**Revision to Garage Remodel Plans
to change back wall to masonry
due to access blocked by neighbor's fence**

BIELAMOWICZ RESIDENCE GARAGE RENOVATION

2111 Wilson Street, Austin, Texas 78704

ISSUED FOR REVISION #1 - OCTOBER 26, 2020

PHASE "A" DEMO AND FLOOR PLAN

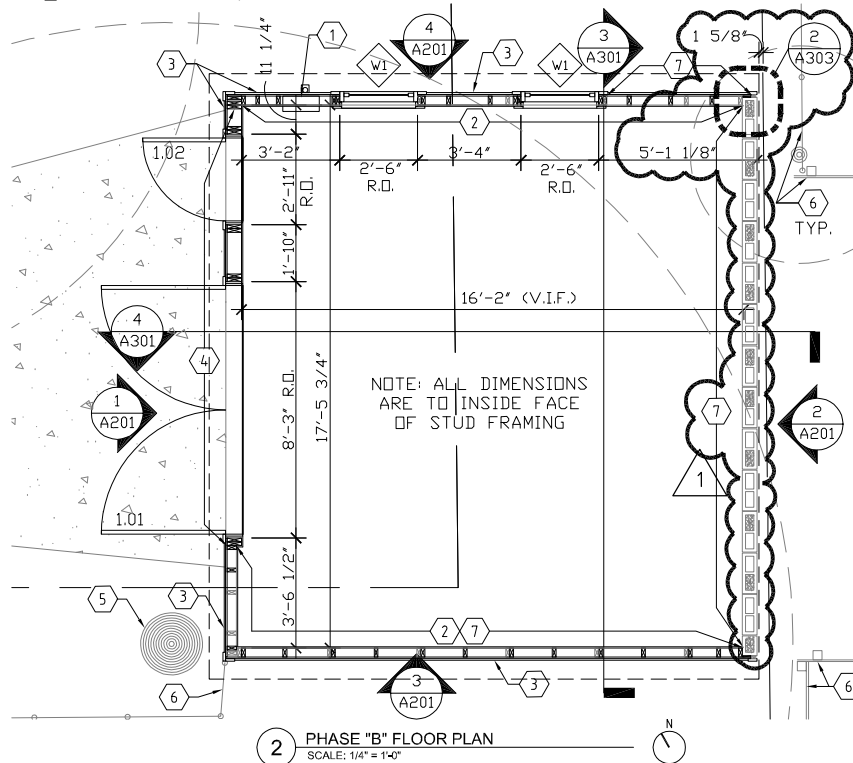
PHASE "A" FLOOR PLAN KEYED NOTES

- ① NEW 6" CMU WALL. WALL TO BE MIN. 1-HR FIRE RATED PER UL U906. BLOCKS TO BE TYPE D2. GROUT EVERY 3RD CELL W/ #4 BAR.
- ② PROVIDE ADD'L 2x4 STUDS IN EXISTING WALL AS NEEDED. FASTEN NEW WALL TO EXISTING WALL PER IRC TABLE R602.3(1) FASTENING SCHEDULE, LINE 9.
